Access Compliance Report

Public Rights-of-Way

Intersection ID: N/A	Main Street: PERIMETER_PY	Cross Street: N/A	Location: SE
ADA ID: 61BE5B141611	Ramp Type: PerpDiag	Initial Pass/Fail: Fail	Overall Compliance: No
		Severity Score: 25

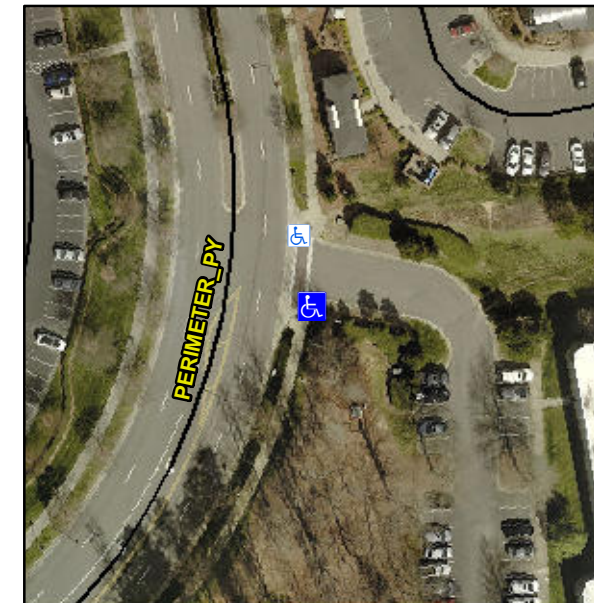
Not Found, R304.5.3

Compliance	Description	Data	Compliance	Description	Data
N/A	Ramp Length (in)	75.0	Yes	Ramp Slope (%)	6.6
Yes	Ramp Width (in)	48.0	No	Ramp XSlope (%)	7.0
N/A	Flare Type LT	N/A	N/A	Flare Type RT	N/A
N/A	Flare Slope LT (%)	N/A	N/A	Flare Slope RT (%)	N/A
N/A	Flare Traversable LT?	No	N/A	Flare Traversable RT?	No
N/A	Landing Length (in)	N/A	N/A	DWS Provided?	N/A
N/A	Landing Width (in)	N/A	N/A	DWS Contrast?	N/A
N/A	Landing Slope (%)	N/A	N/A	DWS Length (in)	N/A
N/A	Landing X Slope (%)	N/A	N/A	DWS Full Width?	N/A
N/A	Landing Curb? (Y/N)	N/A	N/A	DWS Offset (in)	N/A
N/A	Shared Landing?	N/A			
N/A	Gutter Ponding?	N/A	N/A	Gutter Slope (%)	N/A
N/A	Gutter Lip Ht (in)	N/A	N/A	Gutter X Slope (%)	N/A
N/A	Painted X Walk1?	Yes	N/A	Painted X Walk2?	No
	X Walk 1 Direction	To N		X Walk 2 Direction	To W
N/A	X Walk 1 Width (in)	70.0	N/A	X Walk 2 Width (in)	N/A
	X Walk 1 Slope (%)	1.8		X Walk 2 Slope (%)	6.5
	X Walk 1 X Slope (%)	4.8		X Walk 2 X Slope (%)	1.9

Remove & Replace Curb Ramp With Two New Directional Ramps or Equivalent.
